UNITED STATES ENVIRONMENTAL PROTECTION AGENCY
REGION 5
77 WEST JACKSON BOULEVARD
CHICAGO, IL 60604-3590

Re: *Revised MIP Investigation Report and Workplan for High Resolution Characterization*
Tecumseh Products Company, 100 East Patterson, Tecumseh, Michigan 49286
EPA ID#: MID005049440
AOC RCRA-05-2010-0012

Figure 1: MIP-64 Source Depth, and TCE Concentration Trend and Installation Depth of MW-2S

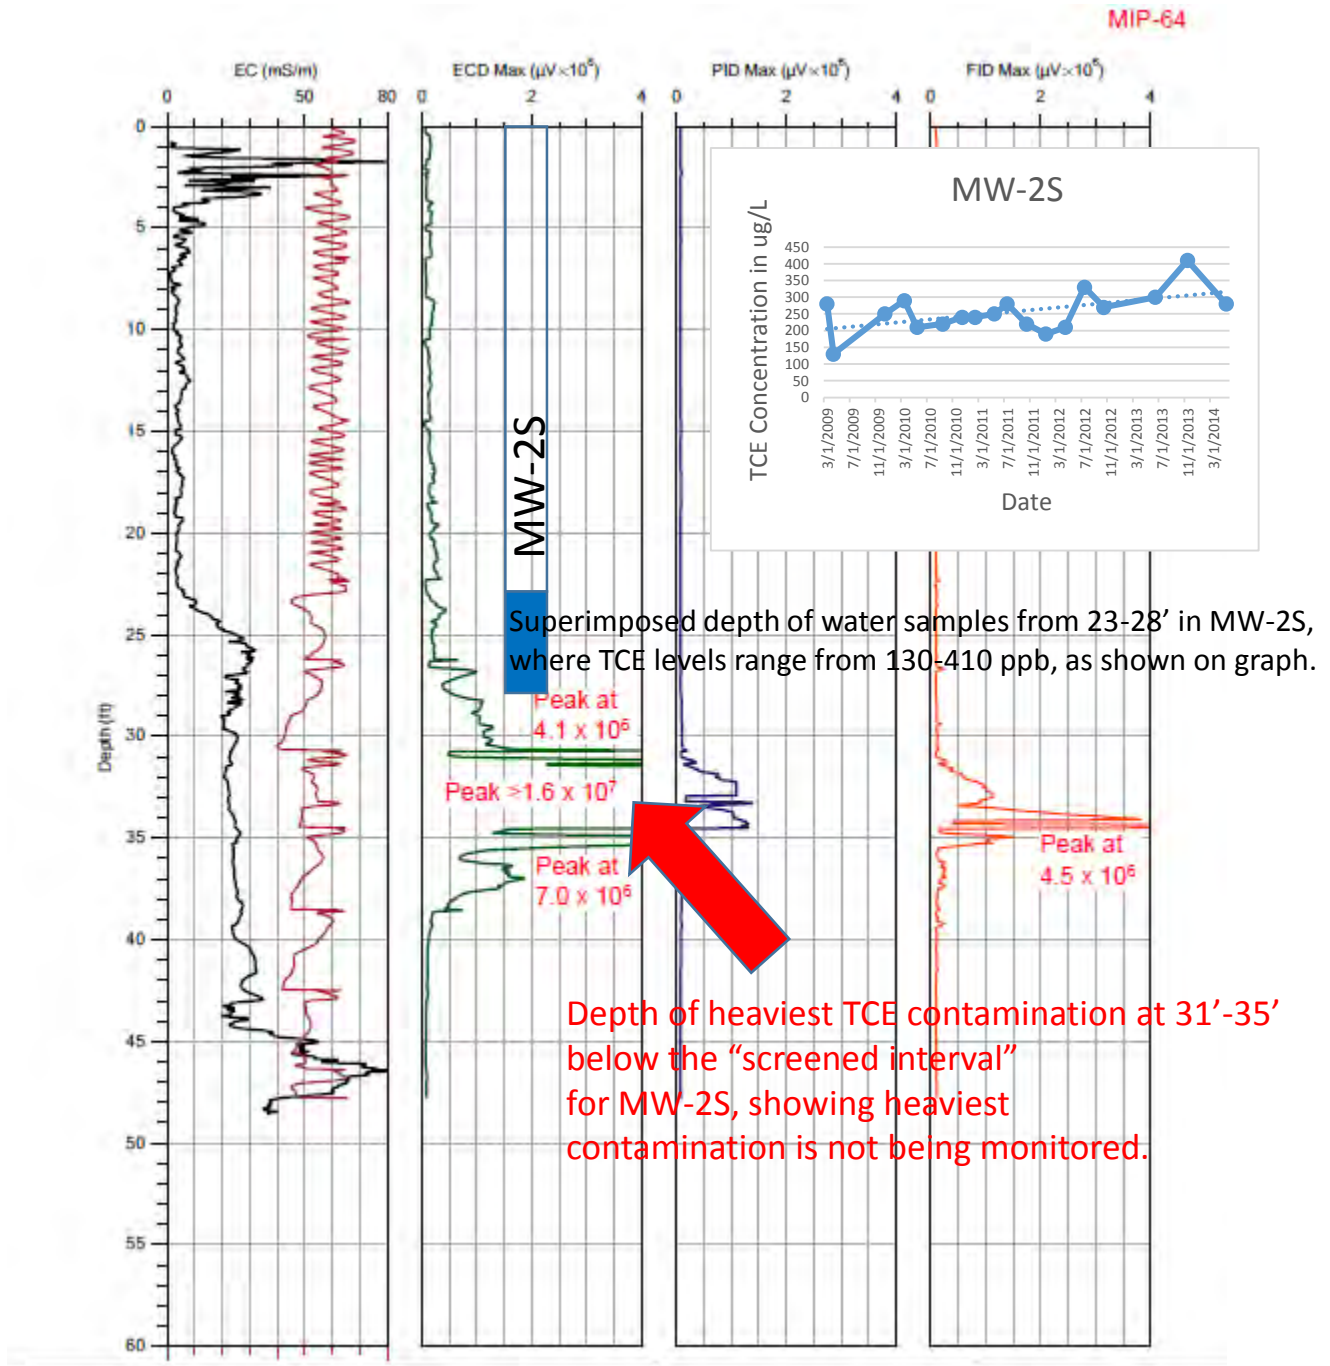
- EPA noted⁵ that many wells appeared to be installed at depths that do not monitor the heaviest groundwater impacts. The attached MIP/ECD logs for MIP-10⁴ and MIP-64⁴ (see *Figures 1 and 2*) are provided as examples which show the depth of TCE contamination relative to the screened intervals based on the well installation diagrams for adjacent wells MW-33S⁶ and MW-2S⁶, confirming this interpretation.

Figure 2: MIP-10 Source Depth, and TCE Concentration Trend and Installation Depth of MW-33S

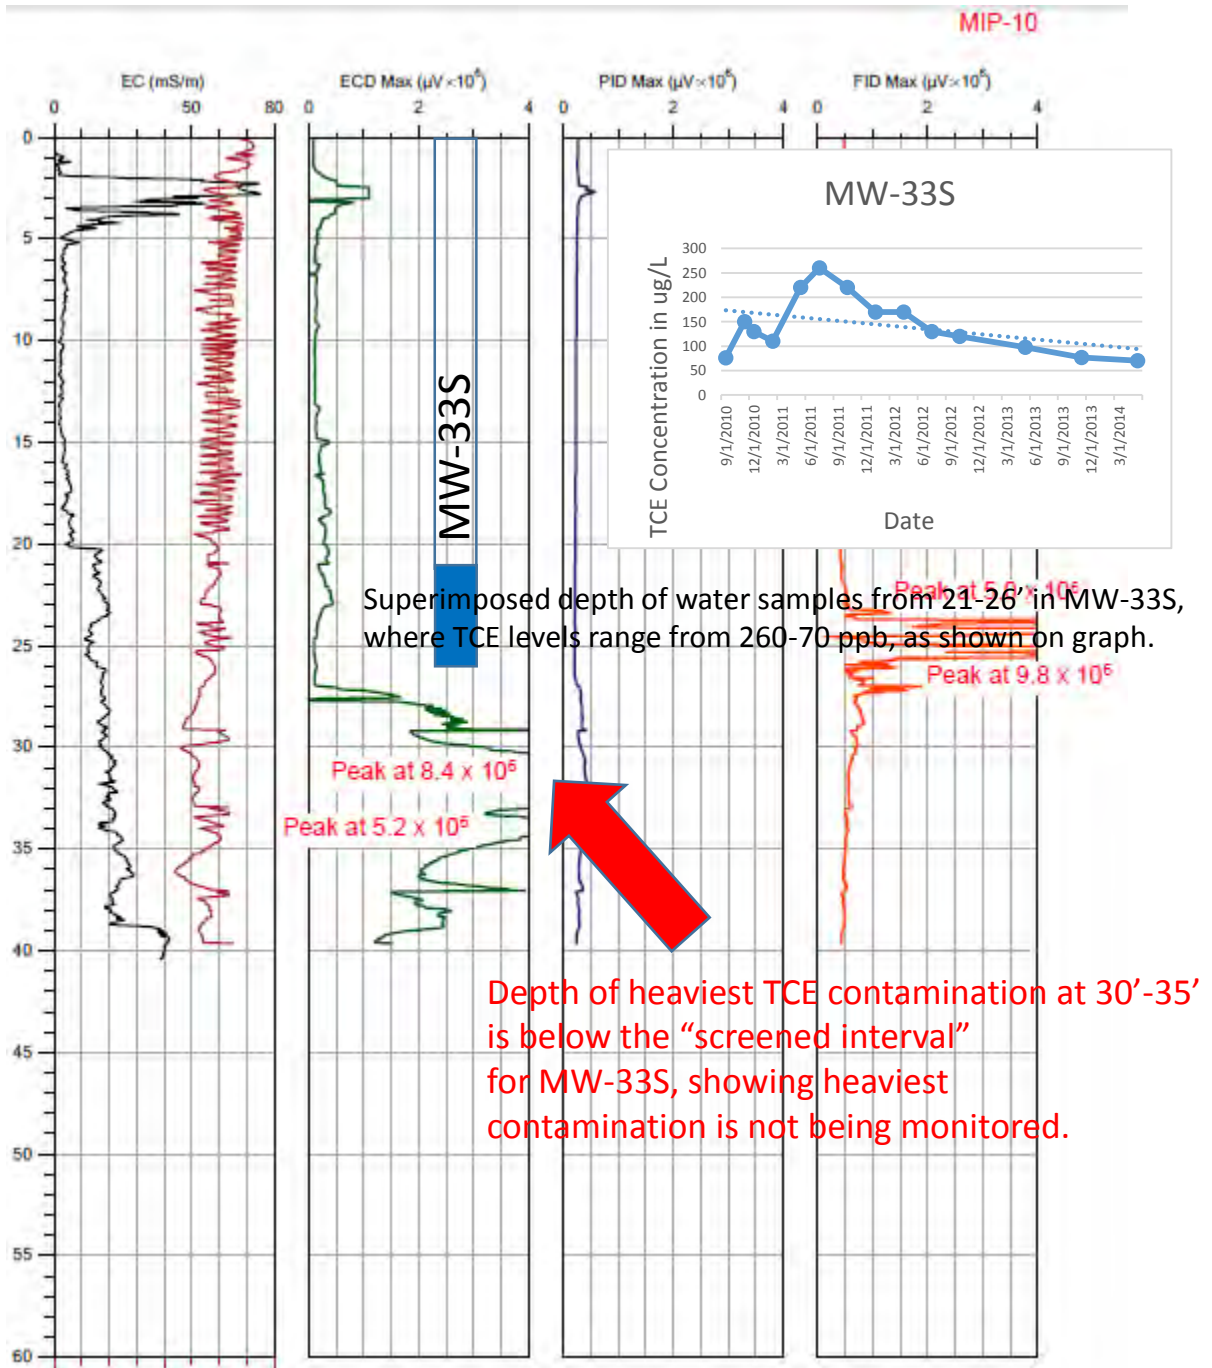
Superimposed depth of water samples from 21-26' in MW-33S, where TCE levels range from 260-70 ppb, as shown on graph.

Depth of heaviest TCE contamination at 30'-35' is below the "screened interval" for MW-33S, showing heaviest contamination is not being monitored.

Figure 3: Locations of MIP Source Areas Relative to Plume Stability Wells, and Well Locations Suggested To TPC in May 2014

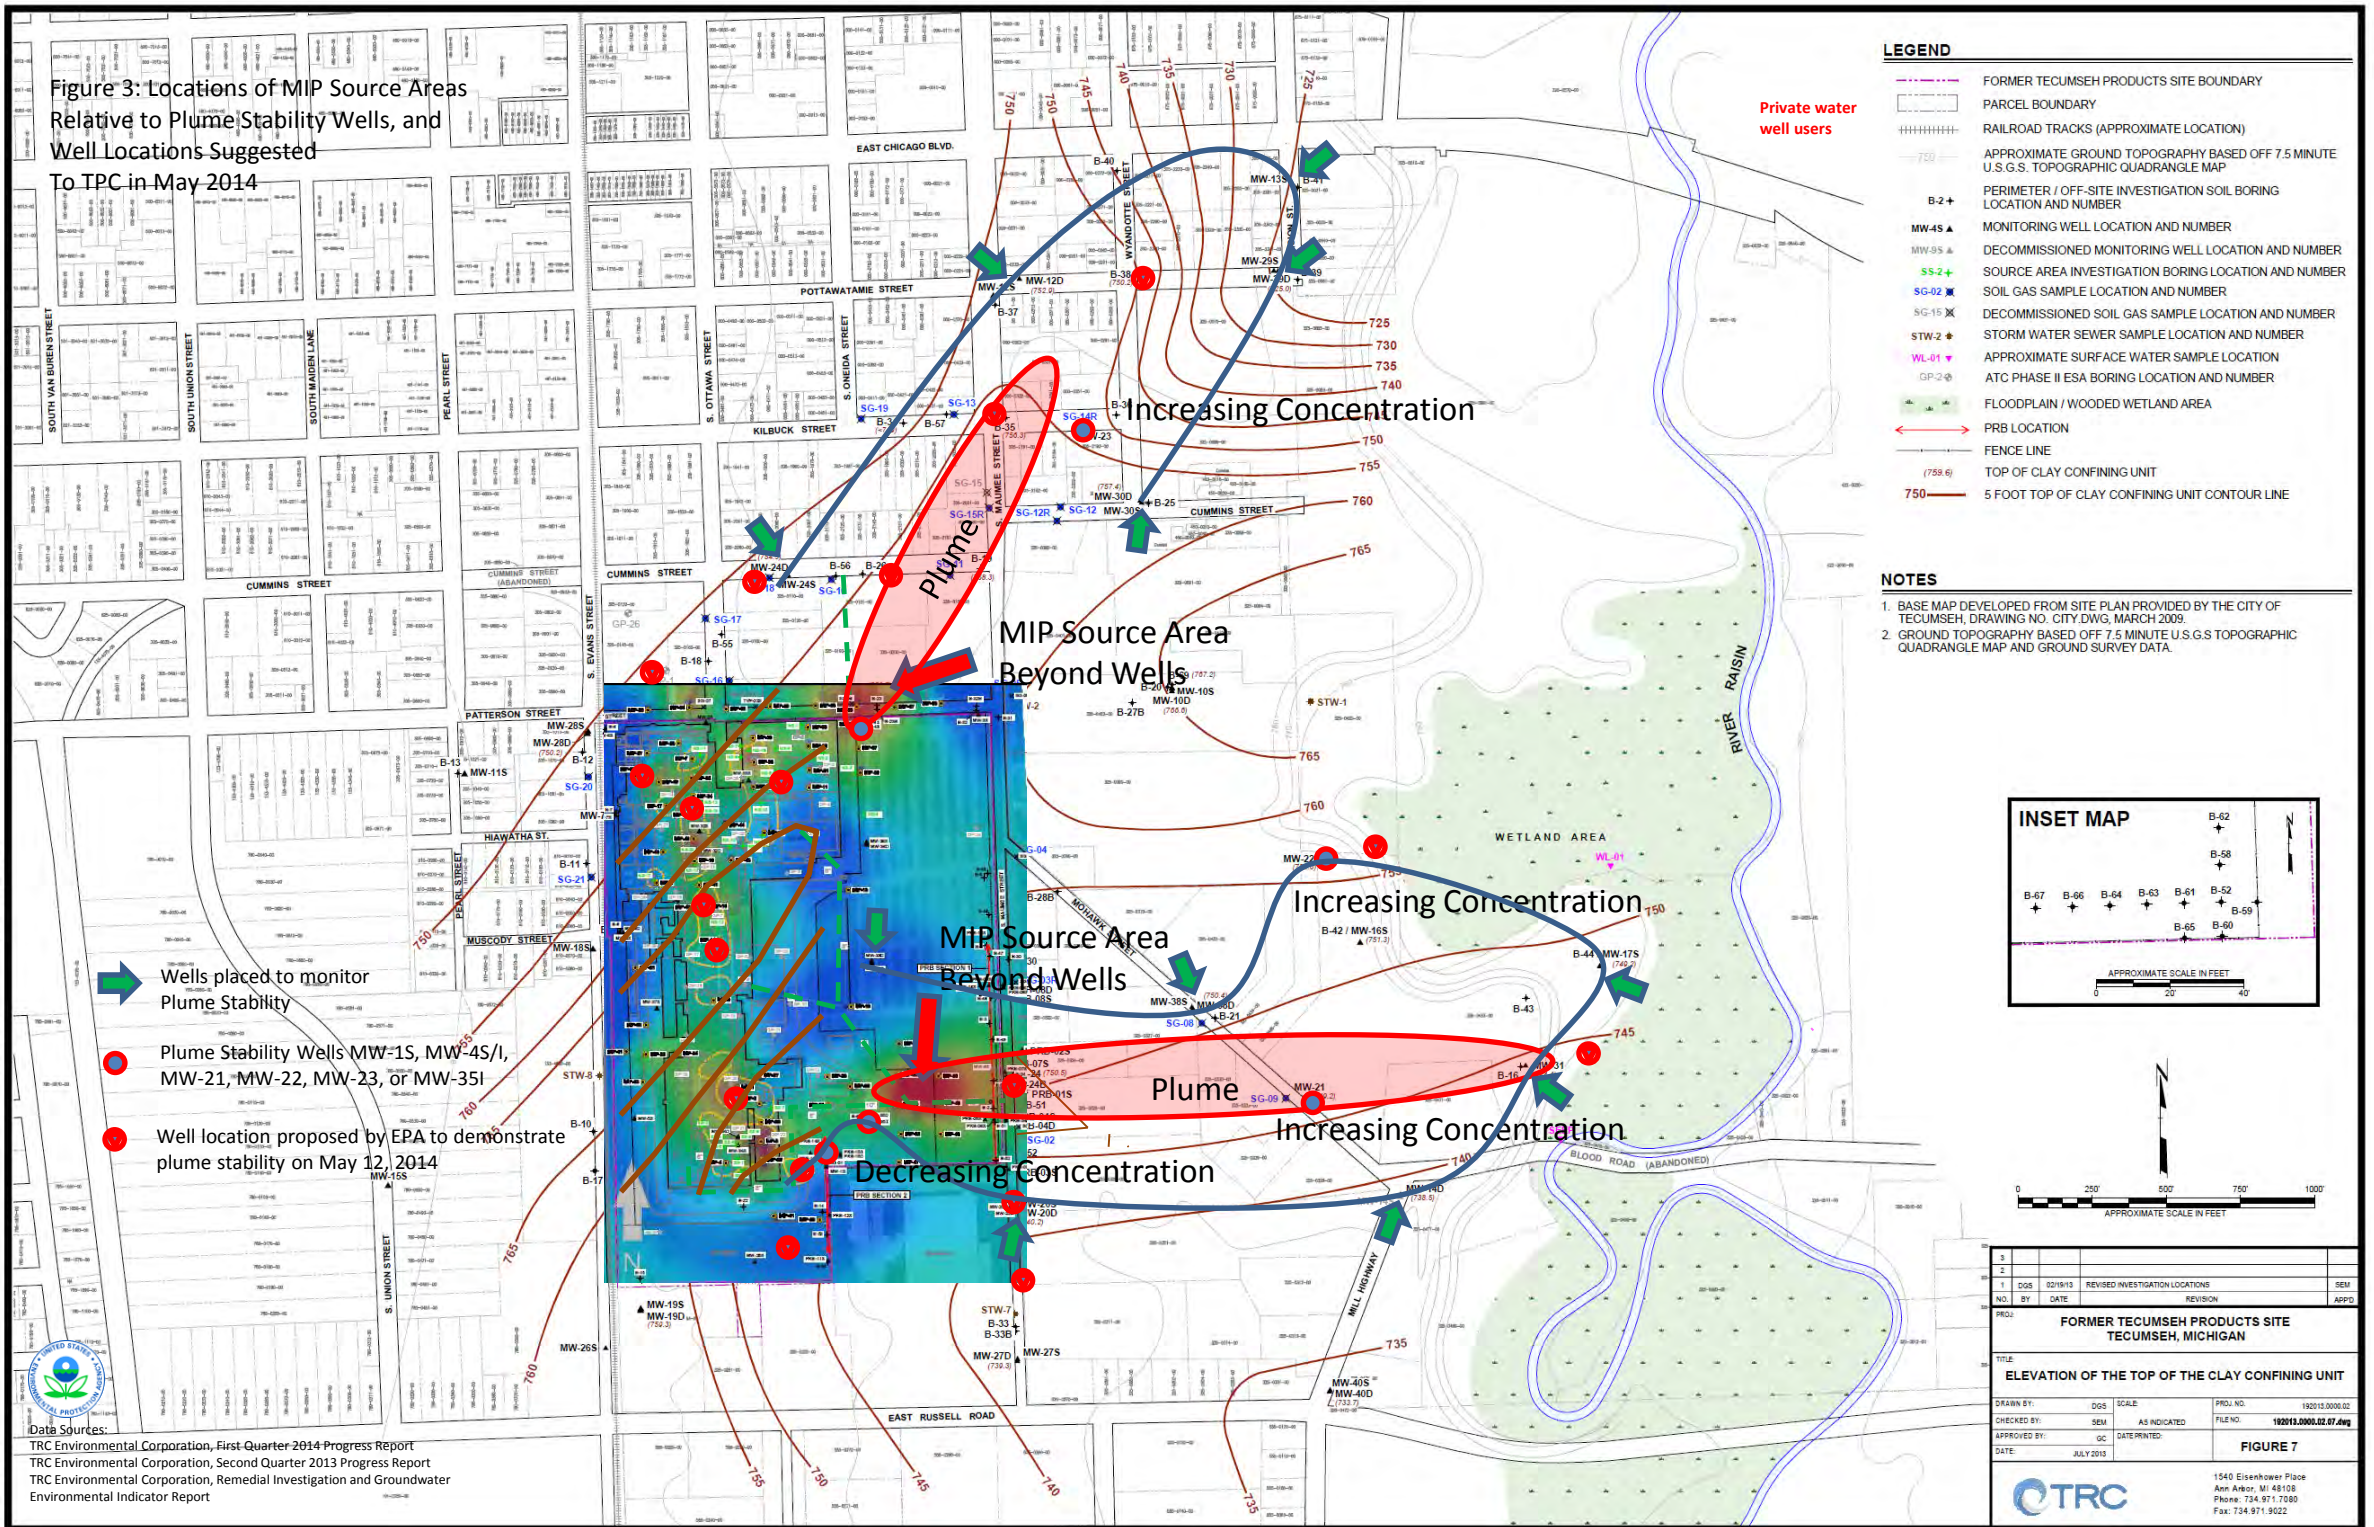
- EPA noted⁵ that areas of heaviest groundwater contamination did not appear to have been characterized, and were not being monitored to evaluate exposure concerns or plume stability, as demonstrated in the attached (see *Figure 3*), which shows the location of permanent monitoring wells MW-35 and MW-21 relative to the contaminant plume located at MIP-19, MIP-23, MIP-49 and MIP-50⁴ in the south [plume truncated to the east due to a lack of data], and the location of permanent monitoring wells MW-4S/4I and MW-23 relative to the plume located at MIP 36 and MIP-55⁴ in the north [truncated off-site to the north due to a lack of data]. Also presented on the figure are locations for monitoring wells that EPA recommended by email on May 12, 2014 for purposes of monitoring the plumes, and the locations of current wells in the north that do not allow for an accurate interpretation of the increases at MW-23⁷.

Figure 4: Depth of TCE at MIP-50 and MIP-23, relative to depth of Permeable Reactive Barrier

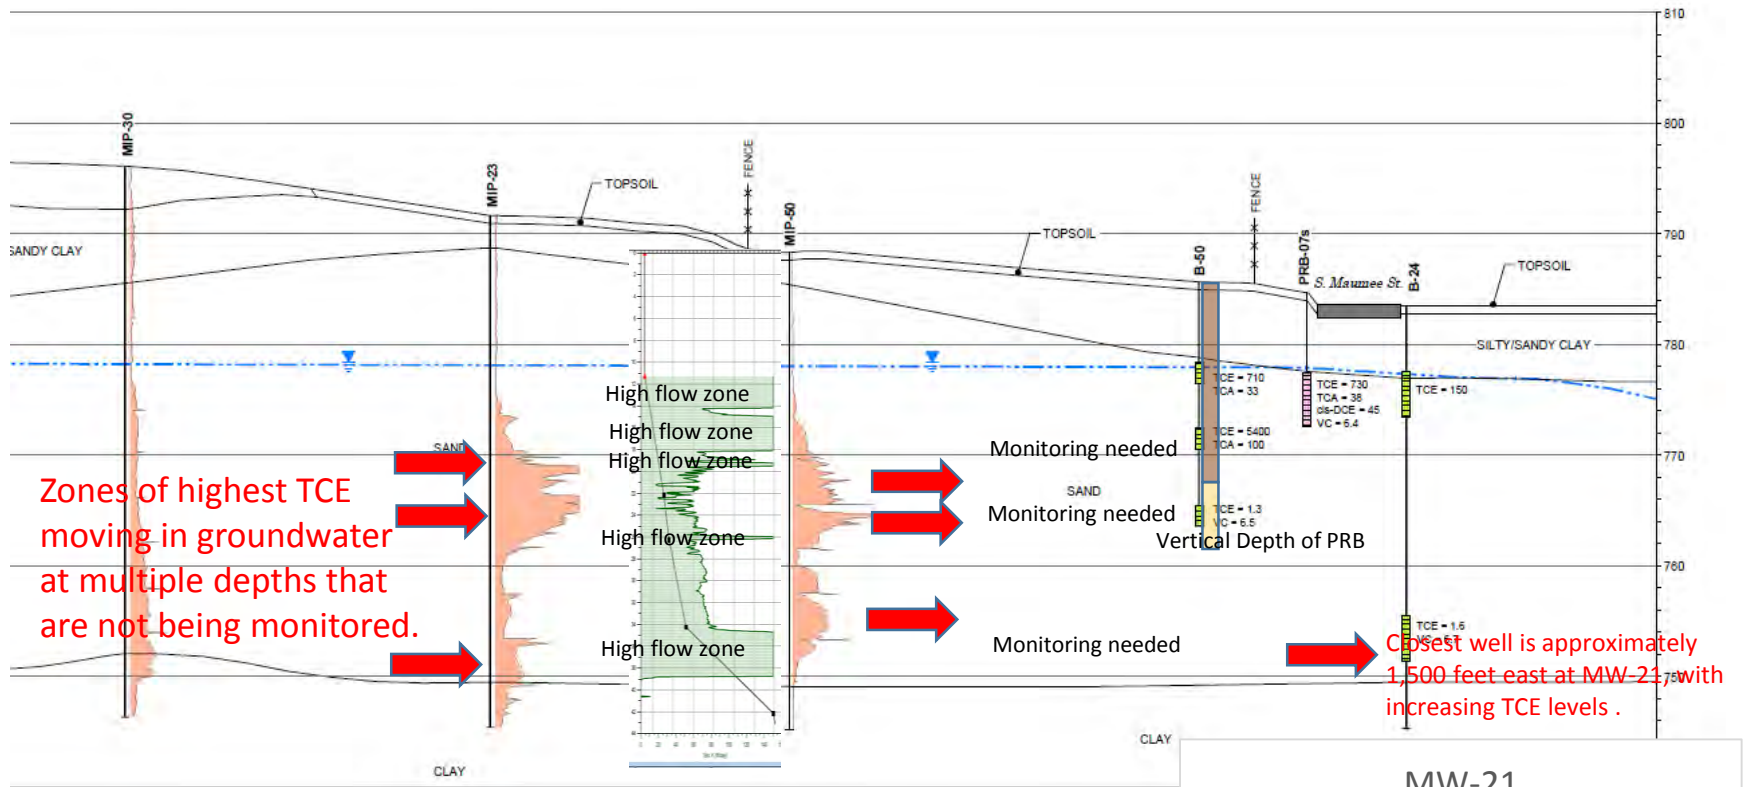
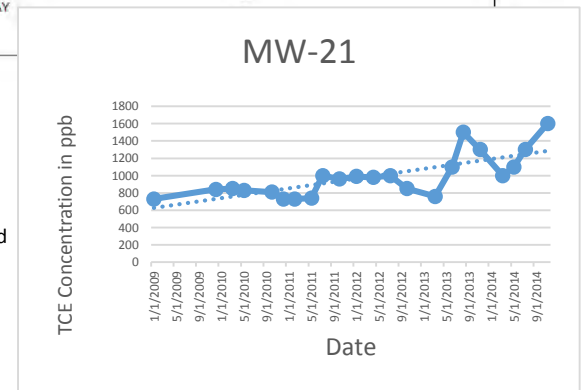
- TCE concentrations in MW-21 continue to increase⁷ and the MIP log for MIP-50 (28-38')⁴ detected a zone of heavy groundwater contamination at an elevation deeper than the PRB² (see *figure 4*). In a May 19, 2011 email to TPC, EPA expressed concerns that contamination may be flowing beneath the PRB and requested deep PRB wells for monitoring. TPC installed PRB-04S and PRB-08S in response, but the wells are positioned at the margins of the contaminant plume¹.

Zones of highest TCE moving in groundwater at multiple depths that are not being monitored.

Closest well is approximately 1,500 feet east at MW-21, with increasing TCE levels.
